Development Review (Minor) Staff Approval

323-SA-2016#2

Dogtopia Patio

LOCATION: 14747 N Northsight Bl Ste 101	APPLICANT: Adrian Wilson
PARCEL: 215-52-0345	COMPANY: Ms Bow Wow, LLC
Q.S.: 34-48	ADDRESS: 14747 N Northsite Blvd Ste 101 scottsdale, AZ 85260
CODE VIOLATION #:	PHONE: (602) 690-5940
Request: Revision to previously approved wall design for enclosed outside play area.

SHEET TITLE:
PATIO PLAN
AND DETAILS

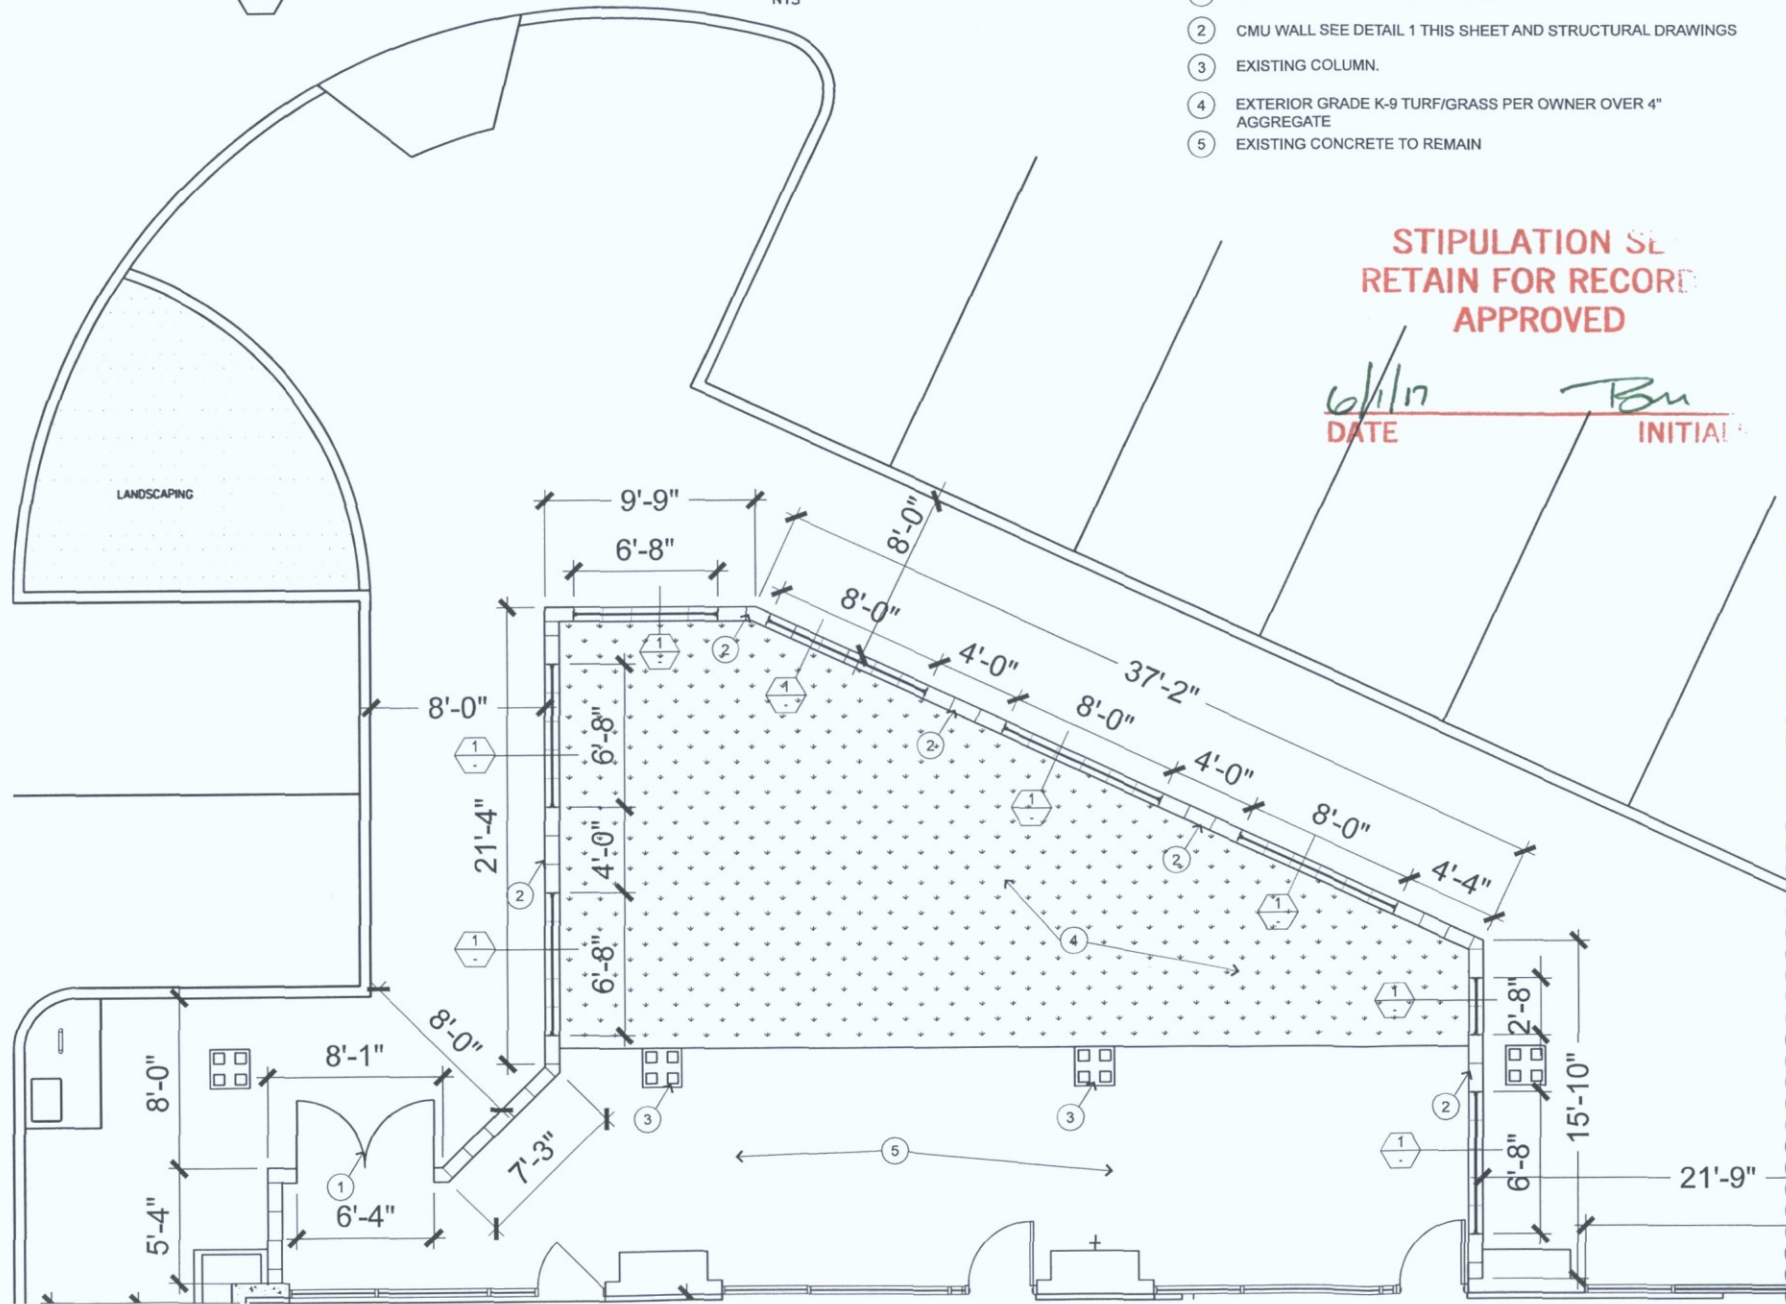
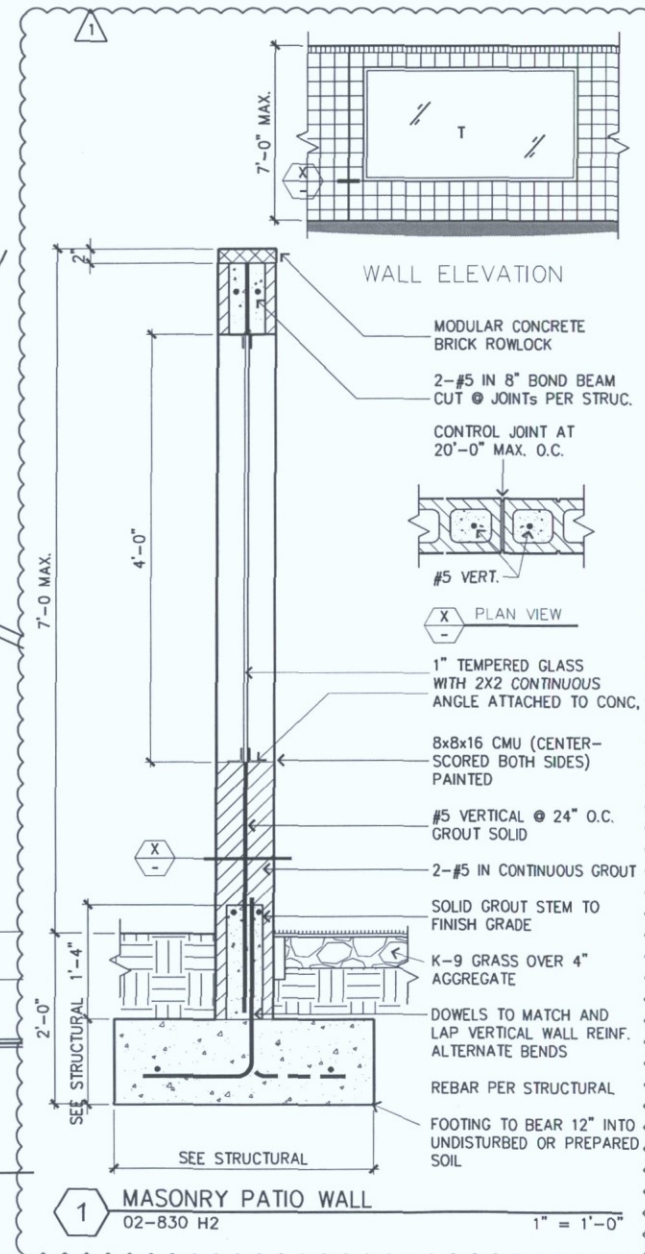
1. The location and configuration of all site improvements shall be consistent with the site plan and detail submitted by Ms Bow Wow, LLC, with a city staff date of 6/1/2017.
2. Shade sails are not approved with this request.
3. Wall finish and color to match existing building finish and color.
4. Mirrored surfaces or any treatments that change ordinary glass into a mirrored surface are prohibited.
5. Reflective building materials are prohibited including materials with high gloss finishes; untarnished copper, aluminum, galvanized steel or other metallic surfaces shall be textured or have a matte or non-reflective surface treatment.

SHADE SAILS NOT
INCLUDED
